**From:** Paul Burgess <paul.burgess@lewisplanning.co.uk>  
**Sent:** 18 November 2025 16:55:51 UTC+00:00  
**To:** "Katherine Williams" <Katherine.Williams@midsussex.gov.uk>  
**Cc:** "Junction Road Selfbuild" <junctionrd@yahoo.com>; "Giles Ings" <giles@abirarchitects.co.uk>  
**Subject:** Re: DM/25/0961 - 201 Junction Road Burgess Hill

**Subject:** 31/10/25 Re: DM/25/0961 - 201 Junction Road Burgess Hill West Sussex RH15 0NX

- Proposed Foul and Storm Water Drainage - DWG No & Rev: 100 P4
- Drainage Details - DWG No 7 Rev 201 P3
- Soakaway Calculations - dated Aug 2025 by Simon Dent Associates
- Infiltration Testing Summary - dated 10<sup>th</sup> October 2025 by Simon Dent Associates

07/04/2025 - Indicative Surface and Foul Water Drainage Proposal 0428.PL.302 rev A was submitted. A soakaway was proposed >20m's away from Networks rails boundary (red arrow)

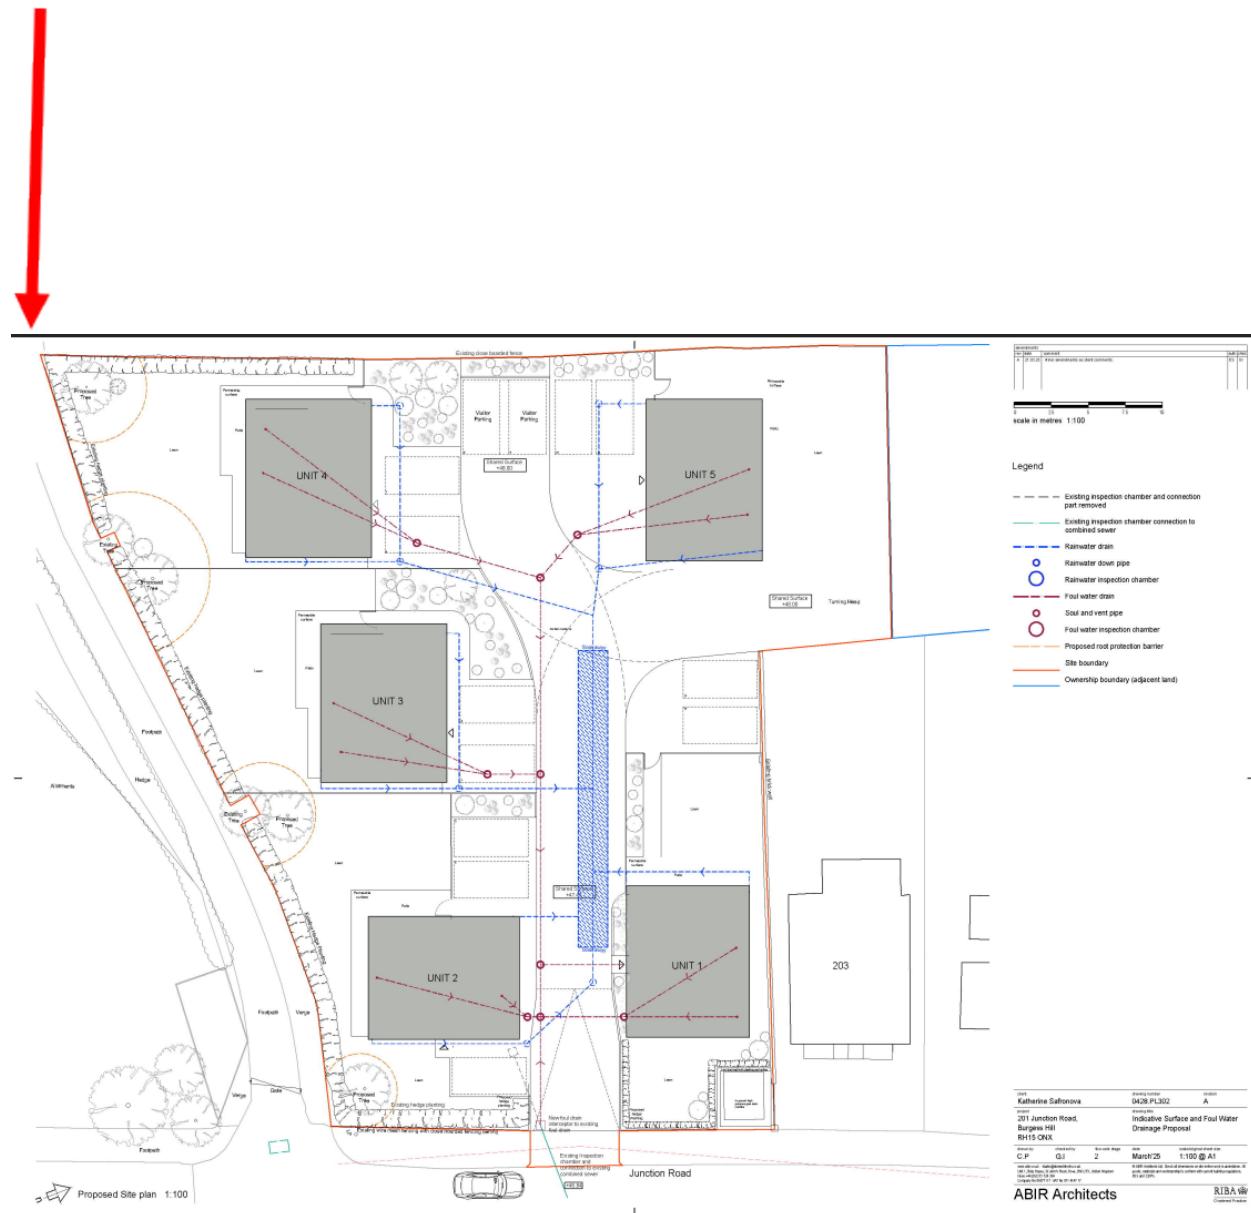
Network Rail should be reconsulted at this stage of the application, based on the design changes submitted.

While the applicant has demonstrated to the Flood Risk and Drainage Team with the latest drainage plan (26/08/25) that the site can be drained it does not comply to Network Rail's Asset Protection requirements, therefore upon reconsult the applicant will need to redesign their strategy. All the key documents attached.

Mr K. Sarker  
261 Junction Road, Burgess Hill  
West Sussex RH5 0NU  
Site Plan, Proposed Flood  
and Storm Water Draining  
FOR PLANNING

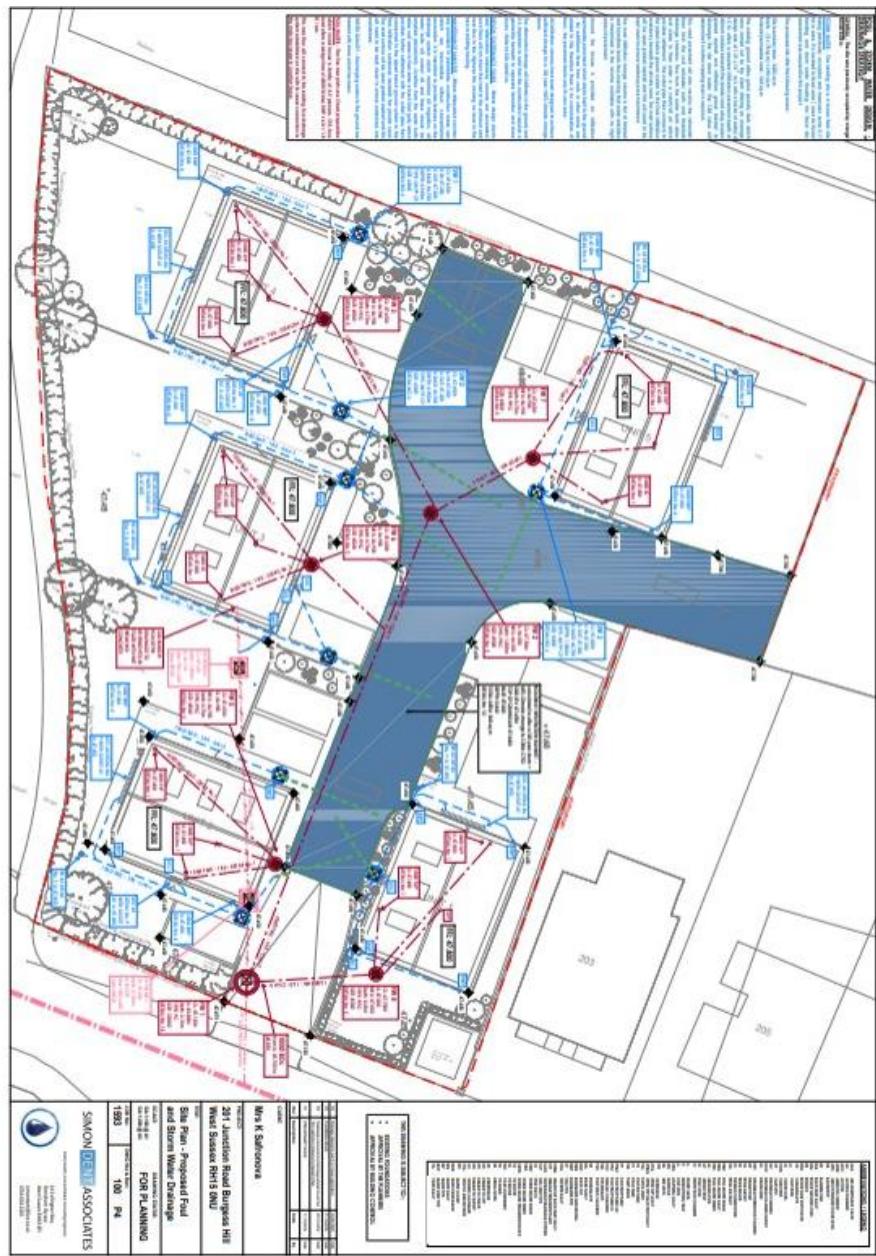
26/08/202 revised Proposed Drainage Site Plan was submitted showing a Drainage Blanket (soakaway feature) < 20 meters of Network Rail land (red arrow).

Further to my email below, the Drainage Consultant has provided the following advice on the shallow SuDS feature and proximity to Network Rail land:

*The road gravel blanket, whilst practically, can be classified as a soakaway, is not constructed as a traditional soakaway in that it is shallow and can spread flows over a larger area than traditional deeper soakaway chambers.*

*In this regard, shallow SuDS features do not represent that risk to nearby structures as the traditional deeper soakaway chambers. The structure of shallow SuDS features attempts to mimic natural run off from green grassed soft areas. This is borne in the CIRIA fact sheet which we attach for your information and issue to the planner should it be required.*

*The shallow SuDS gravel blanket represents less risk than traditional soakaways facilitating a relaxation of the 20m boundary rule imposed by Network Rail.*
